To: T10 Technical Committee
From: Rob Elliott, HP (elliott@hp.com)
Date: 17 May 2004
Subject: 04-115r2 SAS-1.1 Miscellaneous changes

This collects a variety of minor technical (or major editorial) changes, most of which have been highlighted as editor's notes in the last few revisions of SAS-1.1.

Figure 1 — Expander device [updated figure 12]

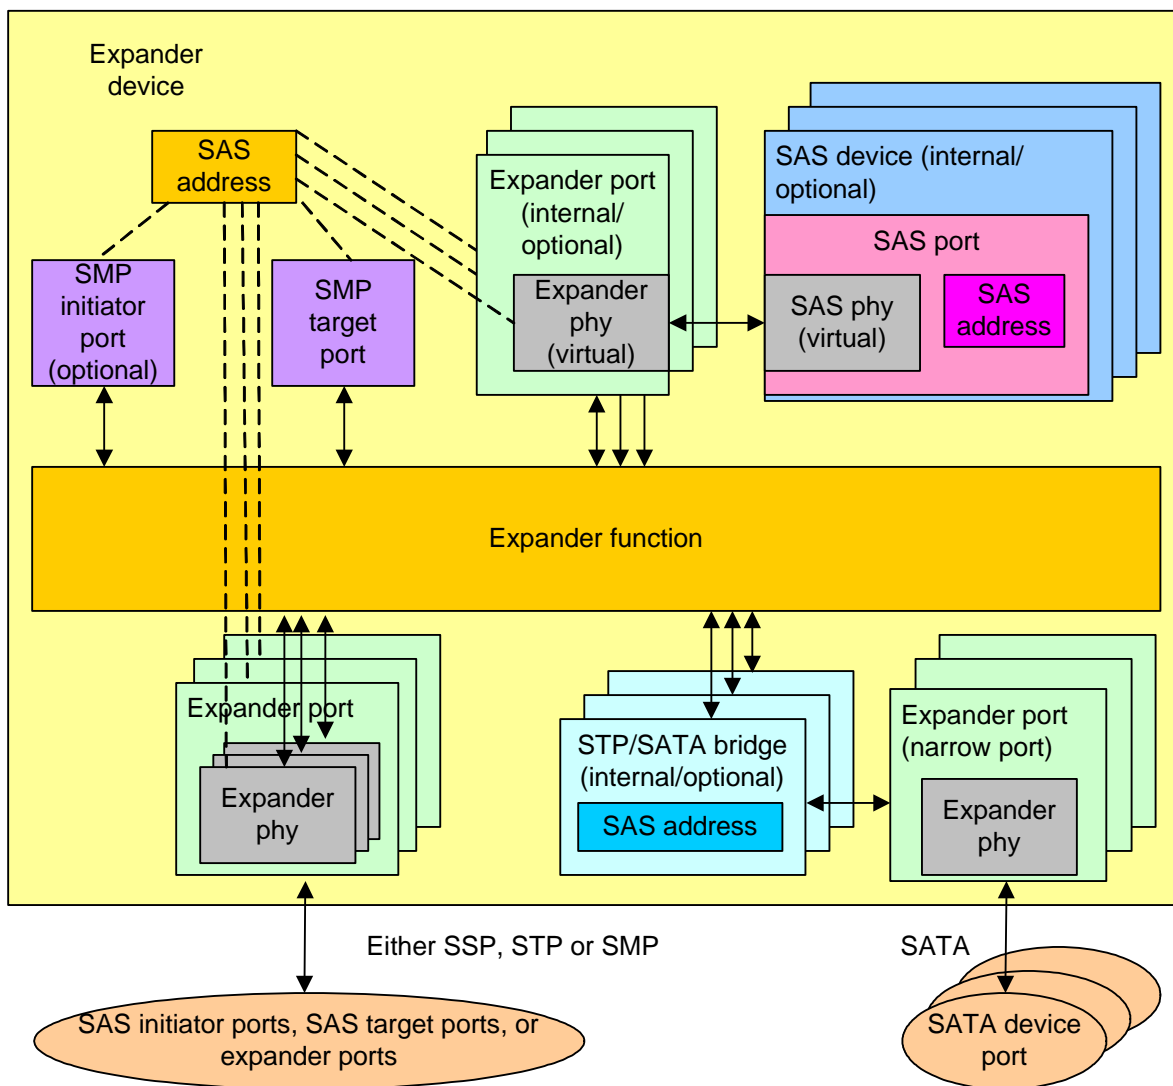
2 Clause 4 - add SMP initiator port to figure 12

Add an optional *SMP initiator port* to figure 12, since if present it shares the expander's own SAS address with the SMP target port. Also add some more phys to the ports in the picture and show the SAS addresses.

Editor's Note 1: May status: OK, with addition of note that each STP/SATA bridge has a unique address

Figure 4 — Transmitting a continued primitive sequence [figure updated]

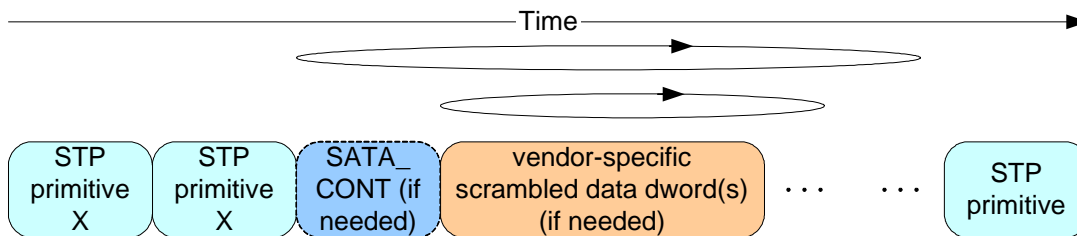
7.2.4.3 Repeated Continued primitive sequence

Primitives that form repeated-continued primitive sequences (e.g., SATA_HOLD) shall be sent transmitted two times, then be followed by SATA_CONT, if needed, then be followed by vendor-specific scrambled data dwords, if needed. ALIGNs and NOTIFYs may be sent inside continued primitive sequences as described in 7.2.4.1. After the SATA CONT, during the vendor-specific scrambled data dwords:

Figure 4 shows an example of transmitting a repeated continued primitive sequence.

Figure 103 — STP target port opening an STP connection [\[modified\]](#)

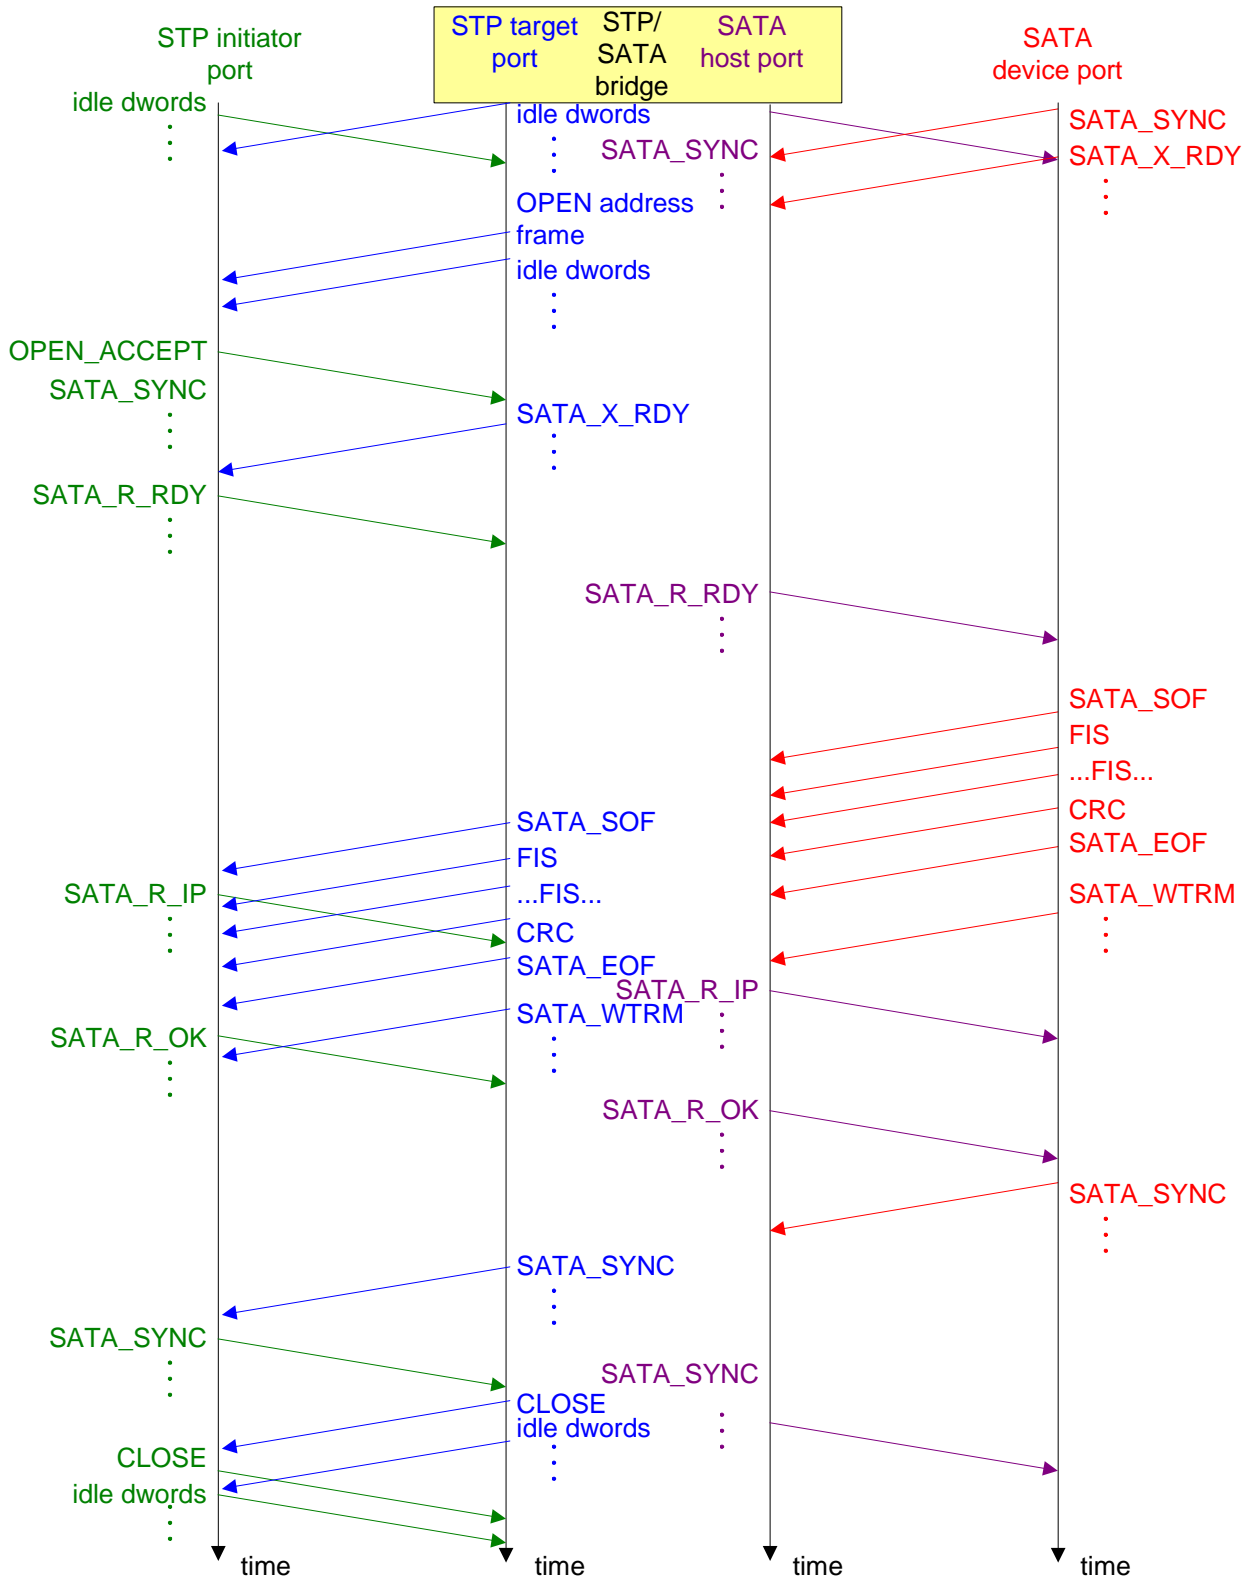
Figure 103 shows after sending OPEN_ACCEPT, an STP initiator continues to send idle dwords before sending SATA_R_RDY. Section 7.17.8 explicitly allows this.

Since it had to decode the protocol to choose to send the OPEN_ACCEPT, it should be ready to start sending SATA_SYNC and should not need to insert any more idle dwords. Require both STP targets and STP initiators do so.

Also, redraw figure 103 so it flows left to right rather than right to left.

[Editor's Note 15: May status: OK, delete AIP from figure](#)

[\[changed idle dwords to SATA_SYNC in what is now the top left\]](#)
